## PHEASANT BRANCH GREENWAY ENHANCEMENT

CITY PROJECT NO. 14370

ADDENDUM #2  
REVISED THE FOLLOWING:  
SHEETS D1-D3  
SHEETS EC1-EC4  
SHEETS G13, G15, G112  
SHEETS P1-P19, P21, P24-27  
SHEETS U1-U18, U22  
SHEETS E1-E6  
SHEET PM1  
SHEETS X32A-X34, X45-X48

14370 MADISON, WI 53717  
 PHEASANT BRANCH GREENWAY ENHANCEMENT  
 EROSION & SEDIMENT CONTROL PLAN  
 CONTRACT NO.: 9517  
 EC1  
 City of Madison Wisconsin  
 14370 EC1

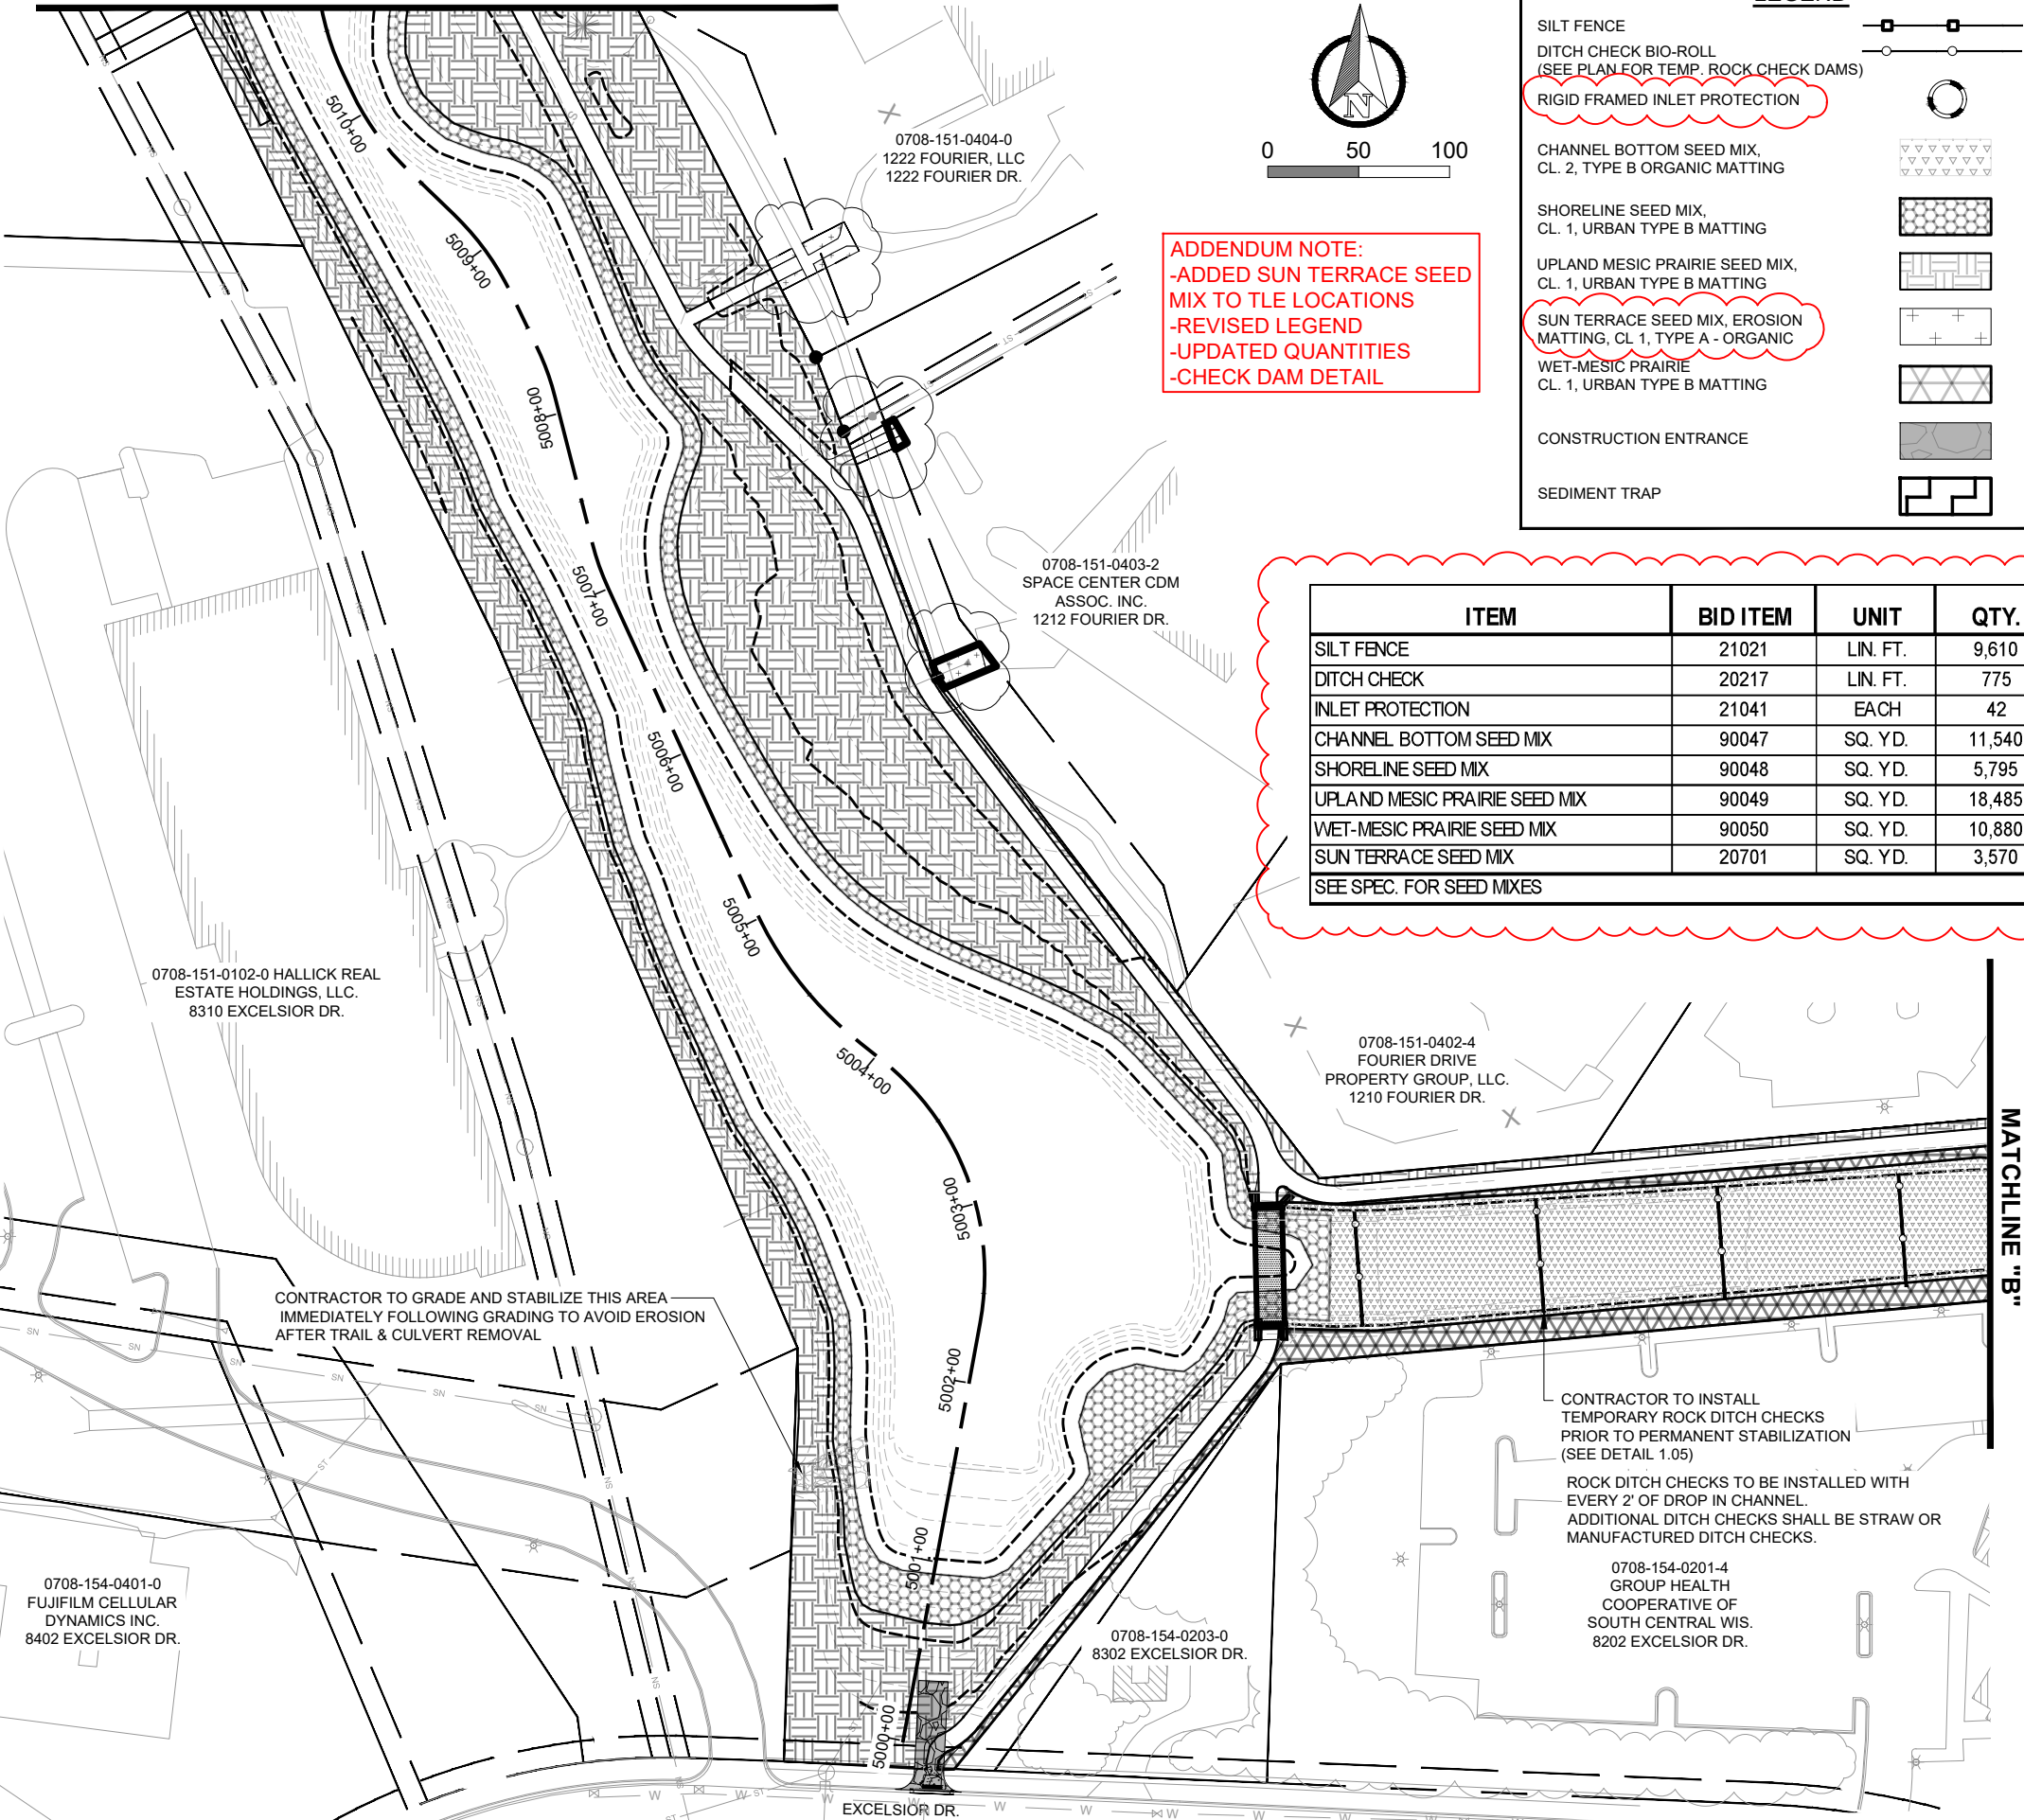
**ADDENDUM NOTE:**  
 -ADDED SUN TERRACE SEED MIX TO TLE LOCATIONS  
 -REVISED LEGEND  
 -REVISED DETAIL D-20  
 -UPDATED QUANTITIES  
 -EXTENDED CONSTRUCTION ENTRANCES  
 -CHECK DAM DETAIL

14370 MADISON, WI 53705  
 EROSION & SEDIMENT CONTROL PLAN  
 PHEASANT BRANCH GREENWAY ENHANCEMENT  
 CONTRACT NO.: 9517  
 EC2  
 Scale: AS SHOWN  
 Date: 11/06/2024 3:57 PM  
 Designed By: JFC  
 MARK  
 REVISION  
 DATE BY  
 14370  
 9517  
 EC2

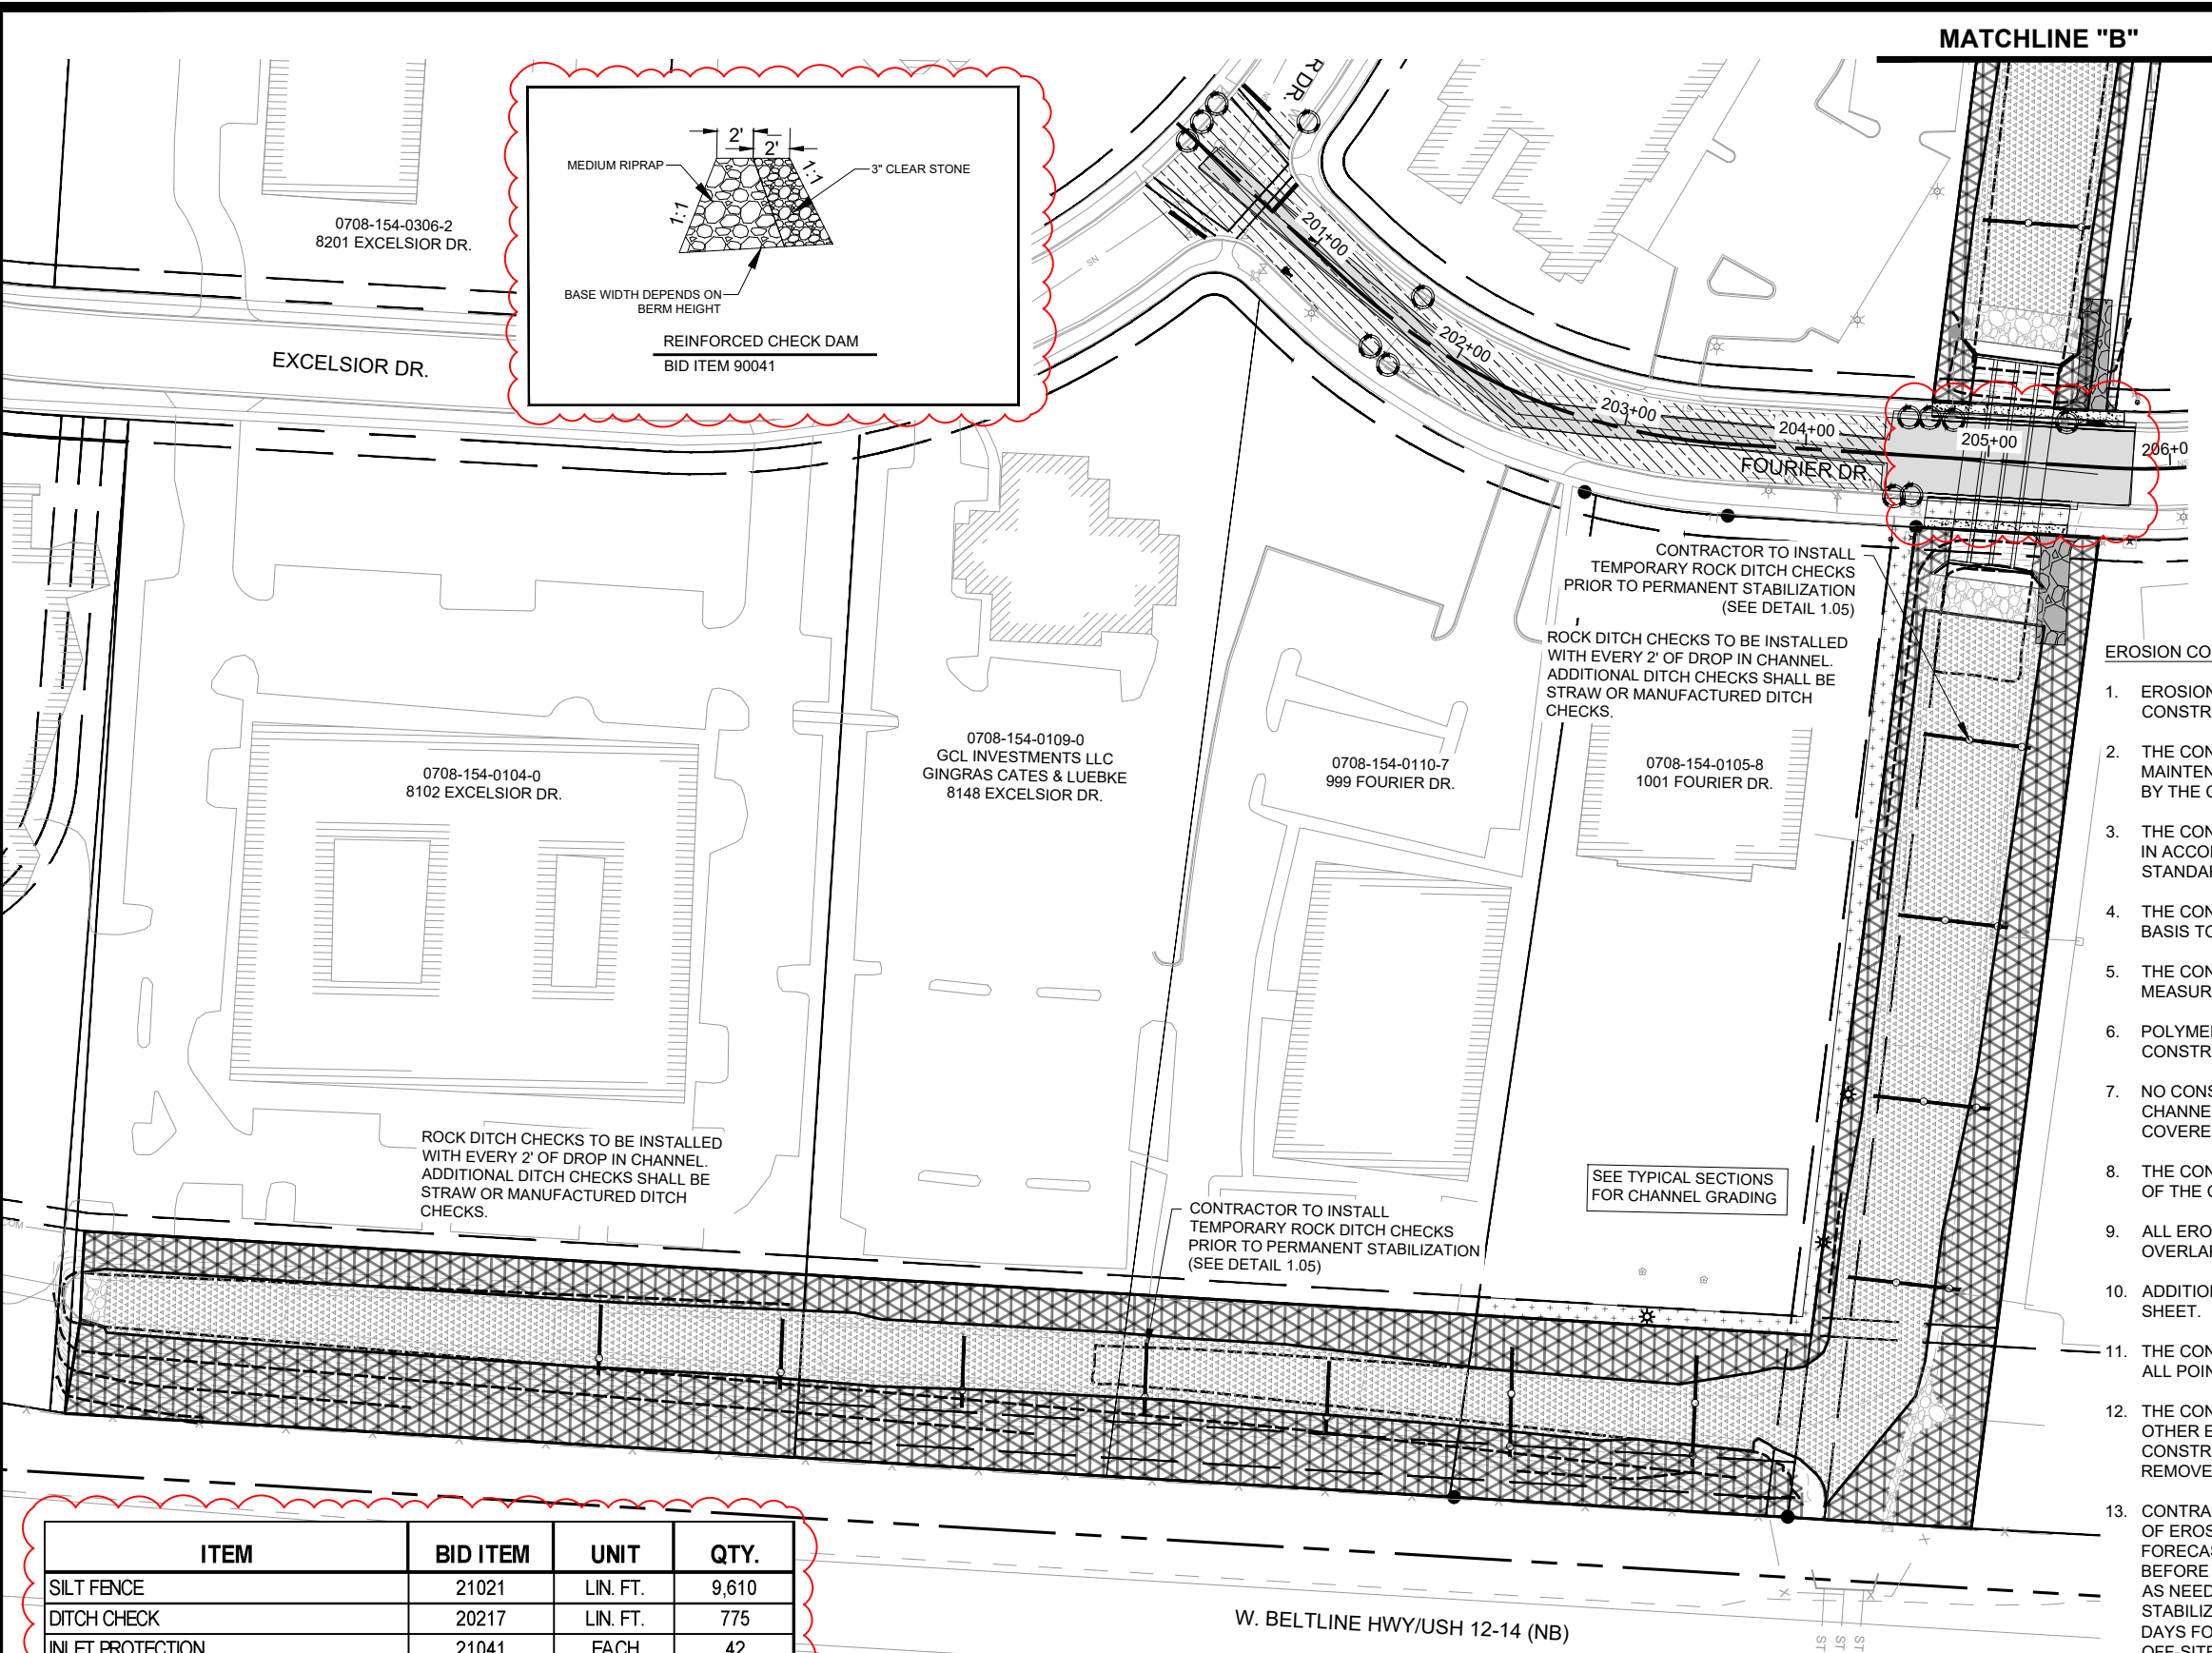
**ADDENDUM NOTE:**  
 -ADDED SUN TERRACE SEED MIX TO TLE LOCATIONS  
 -REVISED LEGEND  
 -UPDATED QUANTITIES  
 -CHECK DAM DETAIL

**14370**  
**EC3**

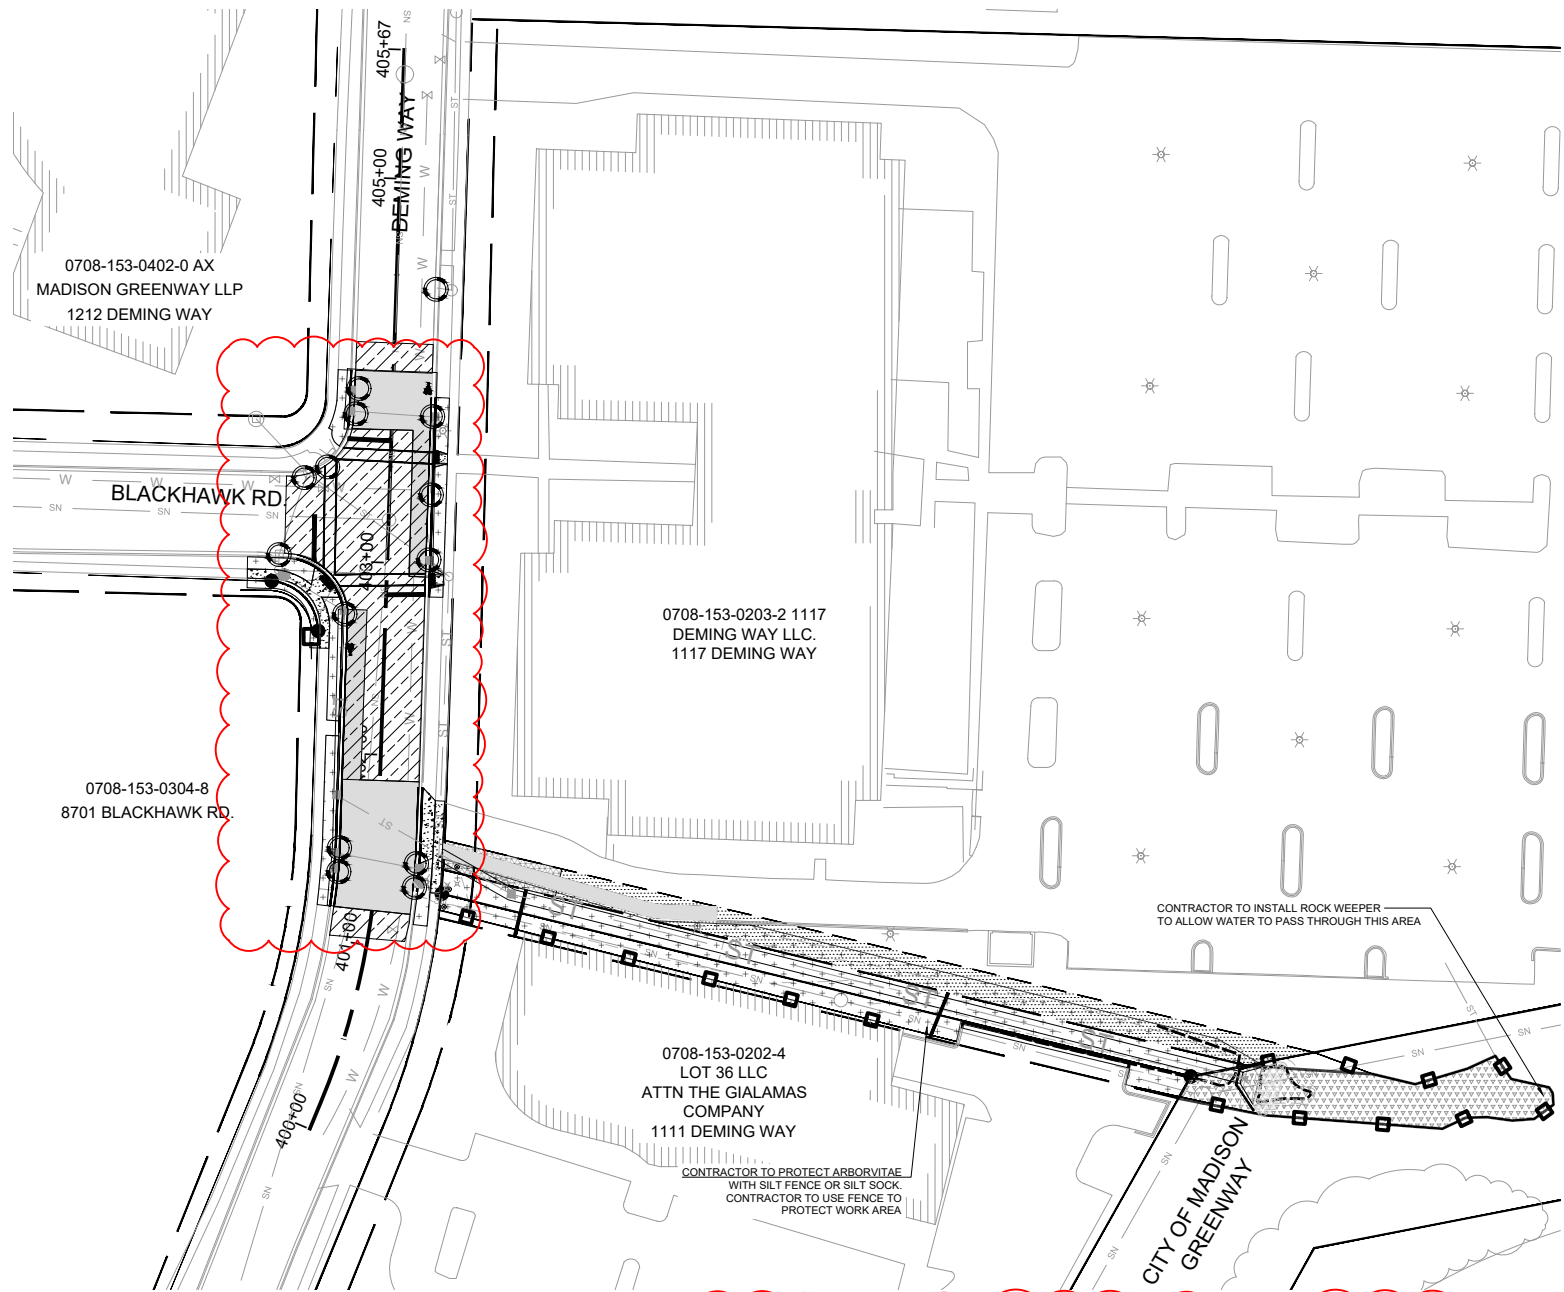
**ADDENDUM NOTE:**  
 -ADDED SUN TERRACE SEED MIX TO TERRACE LOCATIONS  
 -REVISED LEGEND  
 -UPDATED QUANTITIES  
 -CHECK DAM DETAIL
